#### Llwybrau Teithio Llesol Posibl o'r Bont-faen i Ystradowen

#### Adroddiad ar yr Ymgynghoriad

#### Llwybr A

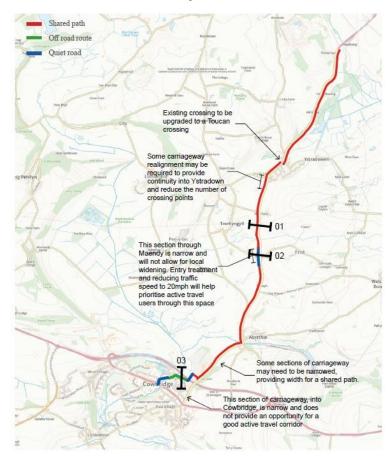
- Ni fyddai'r llwybr yn teimlo'n ddiogel heb wahanu o draffig a heb hyn mae'n annhebygol y bydd defnyddwyr ffordd sy'n agored i niwed yn ei ddefnyddio.
- Llai o effaith amgylcheddol na llwybr B.
- Llwybr lleiaf drud.
